Status Letter for a Draft Plan of Subdivision - Bulat Homes Subdivision
All of Lots 9, 11, 13, 15, 17 and Part of Lot 7, Registered Plan 7211 and Part of Block
121 Registered Plan 72925, Town of Carleton Place, County of Lanark
County File No. 09-T-22005

RE: 09-T-22005 Boyd St Subdivision - Bulat Homes - Updated Submission - SWMP2

Re: Zoning By-law Amendment & Draft Plan of Subdivision – 166 Boyd Street, Town of Carleton Place

SHEET TITLE:
SITE PLAN

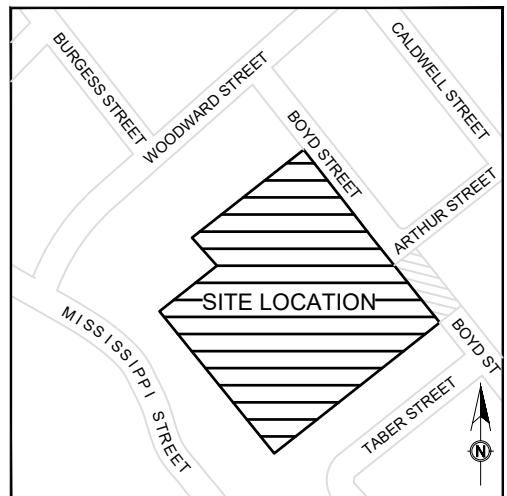
1 Site located between of Block 16 and 15

1 Site located Between Block 11 and 52

- The developer will consult with Canada Post to determine suitable permanent locations for the Community Mail Boxes. The developer will then indicate these locations on the appropriate servicing plans.
